Access Compliance Report

Public Rights-of-Way

(Curb Ramps)

Intersection ID: 15561	Main Street: CUTLER_PL	Cross Street: PIERSON_DR	Location: S
ADA ID: 16D58BE71DB5	Ramp Type: Perp	Initial Pass/Fail: Fail	Overall Compliance: No
Severity Score: 48.75			
Codes/Mitigation Info/Possible Solution		Field Measurements/Component Compliance

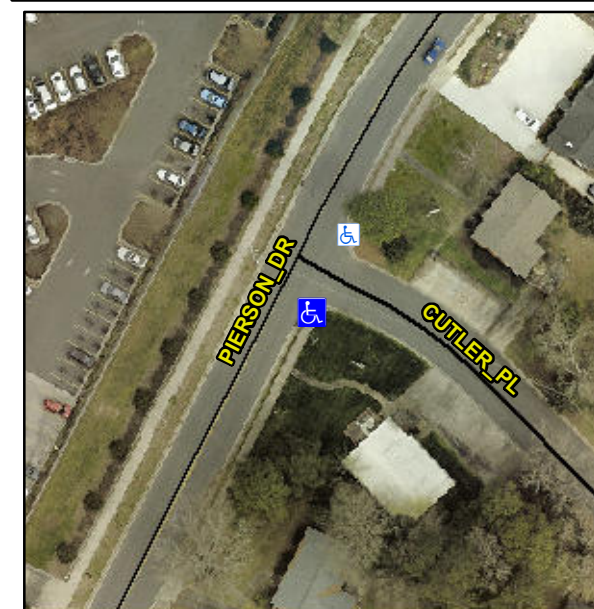
Not Found, R304.5.1, R304.2.2, R304.5.3

Compliance	Description	Data	Compliance	Description	Data
N/A	Ramp Length (in)	40.5	No	Ramp Slope (%)	8.7
No	Ramp Width (in)	31.0	No	Ramp XSlope (%)	2.9
N/A	Flare Type LT	N/A	N/A	Flare Type RT	N/A
N/A	Flare Slope LT (%)	N/A	N/A	Flare Slope RT (%)	N/A
N/A	Flare Traversable LT?	N/A	N/A	Flare Traversable RT?	N/A
N/A	Landing Length (in)	N/A	N/A	DWS Provided?	N/A
N/A	Landing Width (in)	N/A	N/A	DWS Contrast?	N/A
N/A	Landing Slope (%)	N/A	N/A	DWS Length (in)	N/A
N/A	Landing X Slope (%)	N/A	N/A	DWS Full Width?	N/A
N/A	Landing Curb? (Y/N)	N/A	N/A	DWS Offset (in)	N/A
N/A	Shared Landing?	N/A			
N/A	Gutter Ponding?	N/A	N/A	Gutter Slope (%)	N/A
N/A	Gutter Lip Ht (in)	N/A	N/A	Gutter X Slope (%)	N/A
N/A	Painted X Walk1?	No	N/A	Painted X Walk2?	N/A
	X Walk 1 Direction	To NE		X Walk 2 Direction	N/A
N/A	X Walk 1 Width (in)	N/A	N/A	X Walk 2 Width (in)	N/A
	X Walk 1 Slope (%)	1.9		X Walk 2 Slope (%)	N/A
	X Walk 1 X Slope (%)	0.5		X Walk 2 X Slope (%)	N/A

Remove & Replace Entire Ramp.
